T950040

CALIFORNIA INSTITUTE OF TECHNOLOGY
Laser Interferometer Gravitational Wave Observatory (LIGO) Project

Subject: AI 37- Hydrogen and Getter Pumps

Base LIGO configuration:

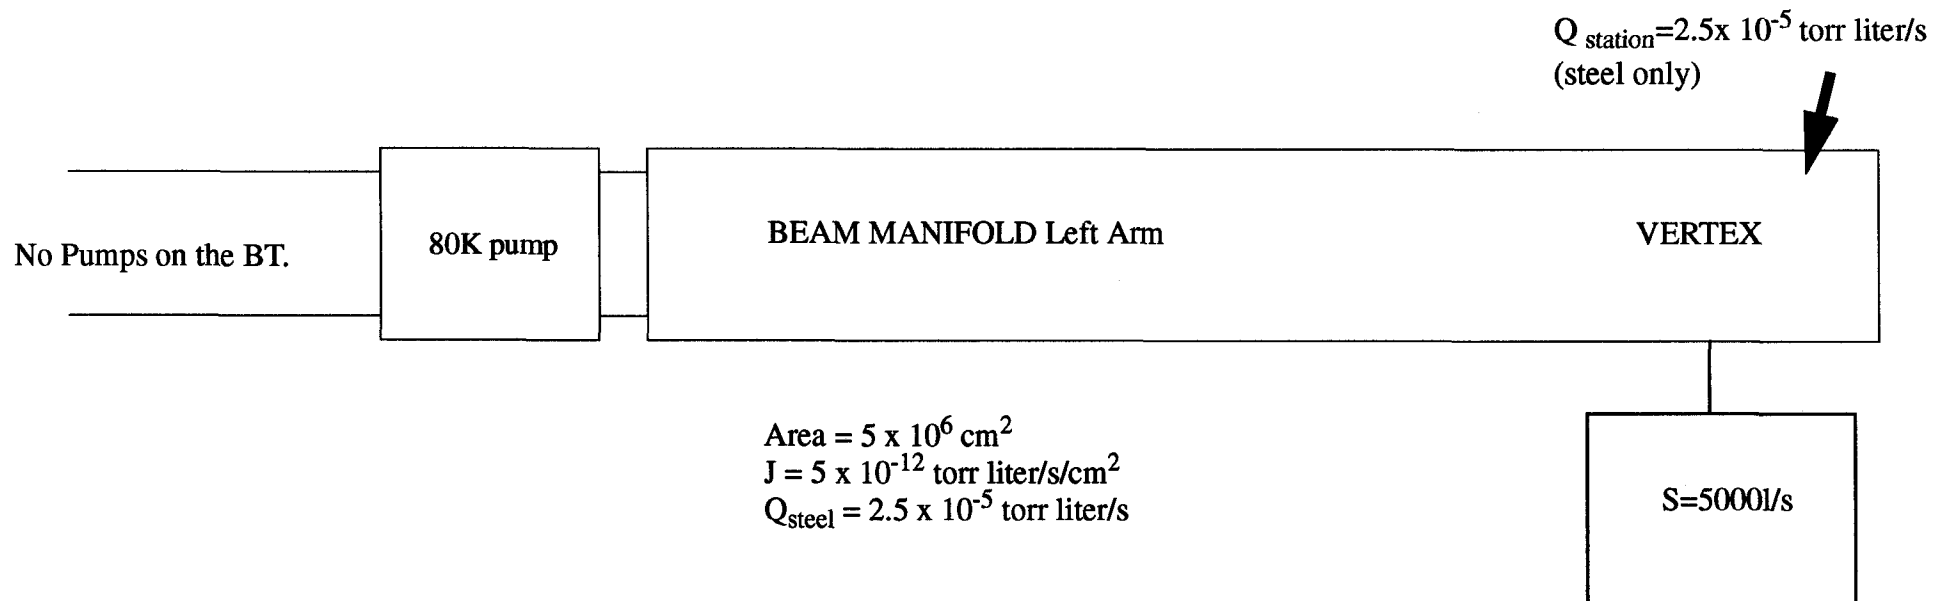
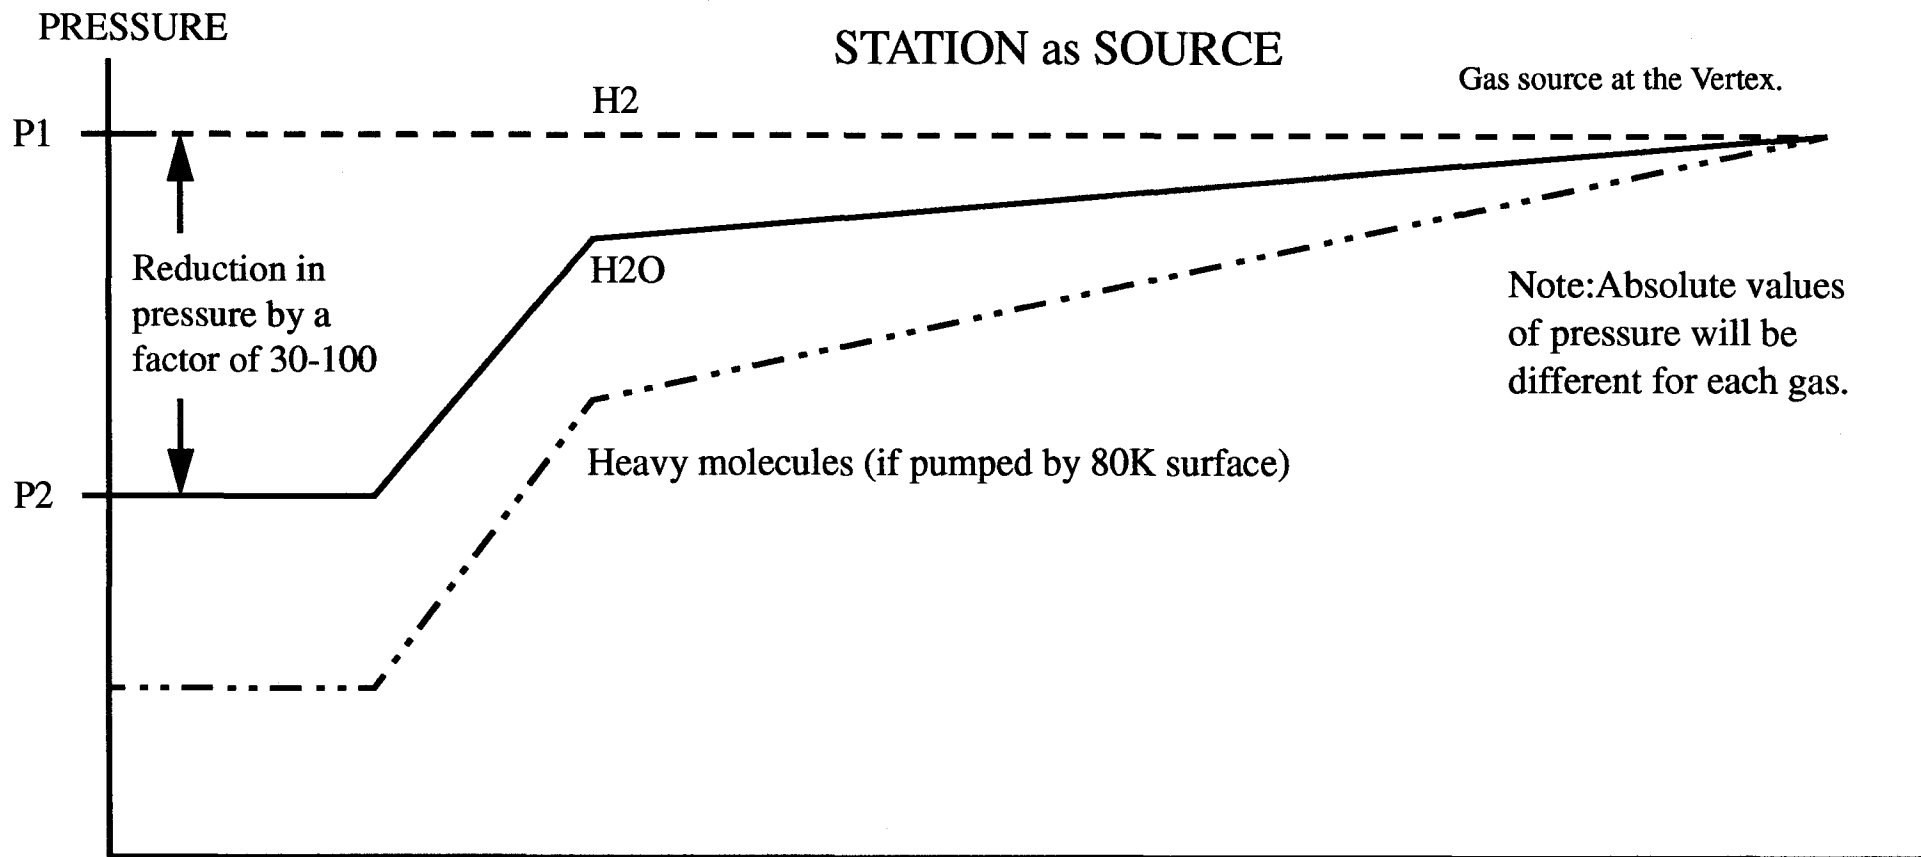
- Hydrogen is pumped only by the station ion pumps. Other gases (with some exceptions) are pumped by the 80K pumps (and the ion pumps).

BT Pressure Mass 2

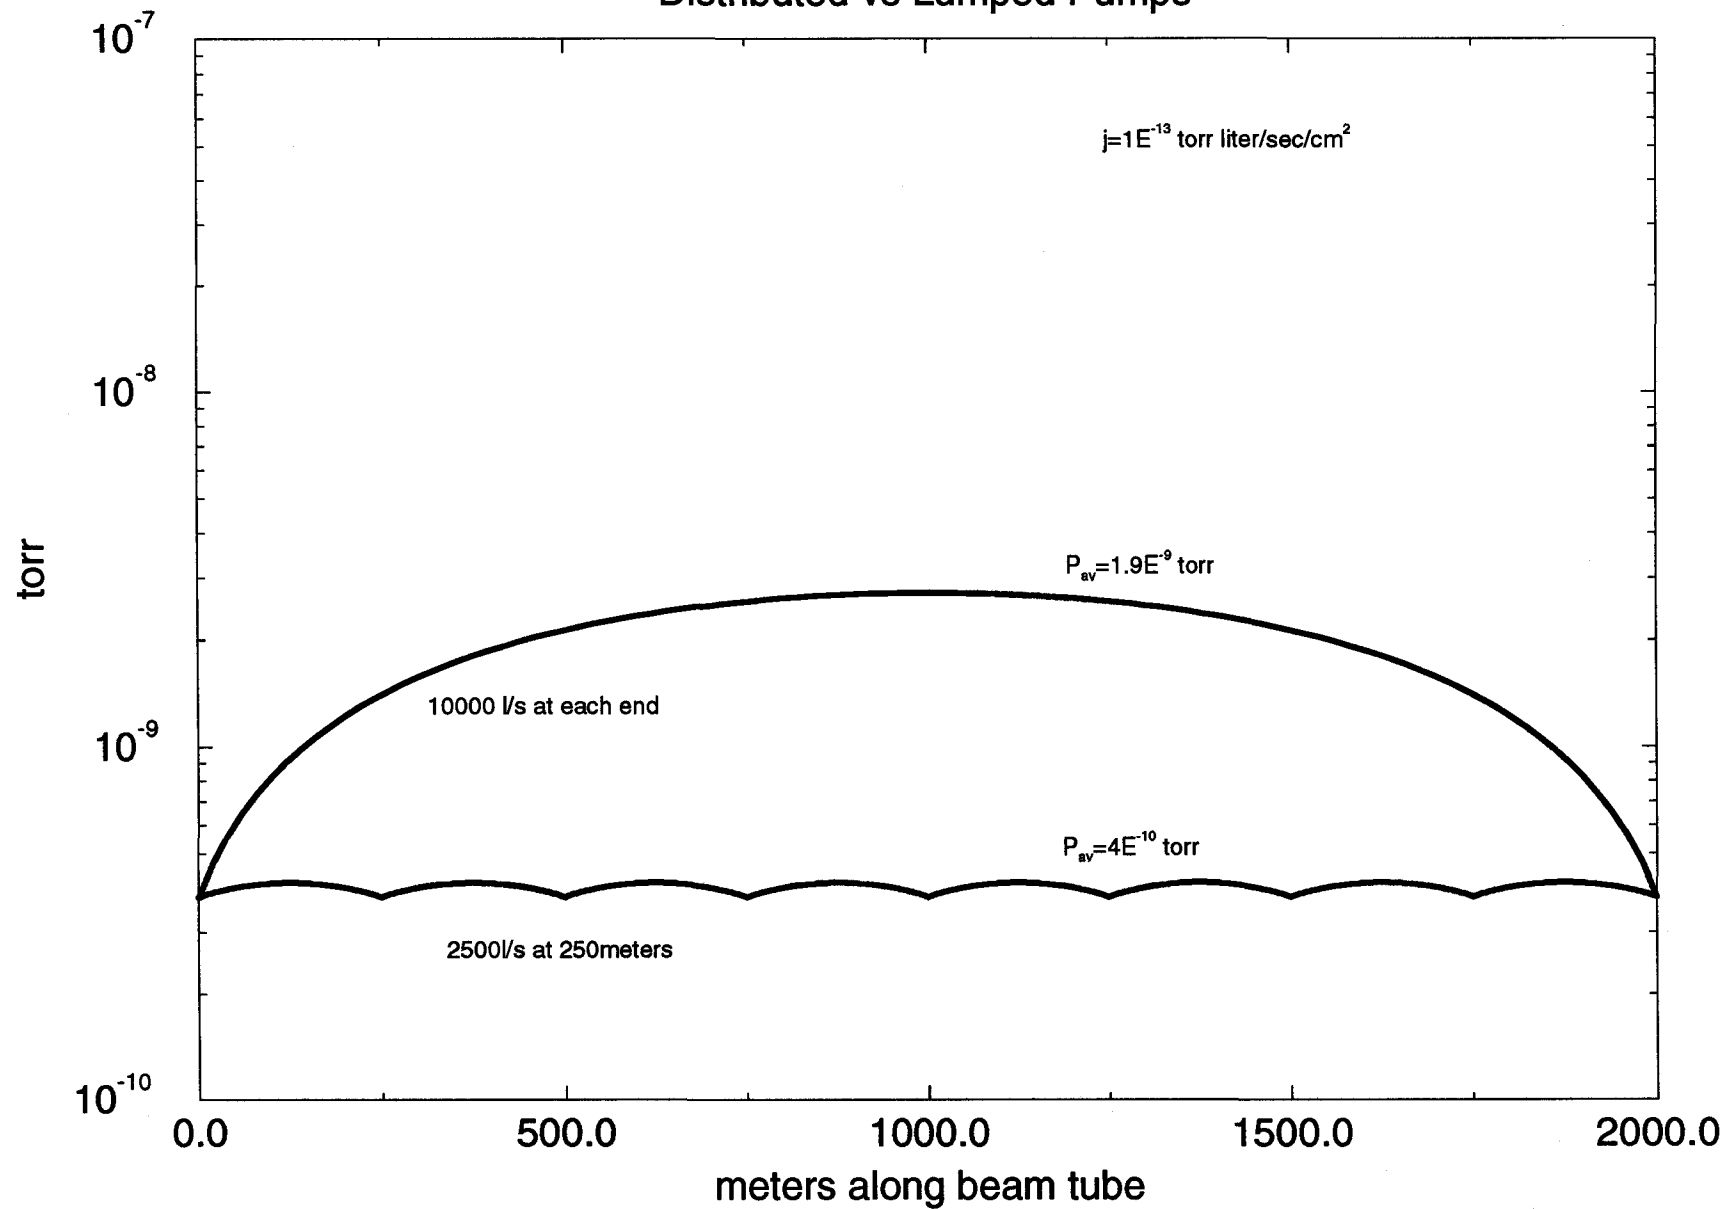
- Station gas dominating:
 - Distributed pumps yield small (~50%) reduction over lumped pumps.
- Beam Tube gas dominating:
 - Distributed pumps yield large (>500%) reduction over lumped pumps.
 - For higher masses this becomes even more significant.

Beam Tube pumps are probably not needed for the initial interferometers. It is unlikely that the IF will be a source of H₂ : Therefore, the BT qualification test will decide this issue.
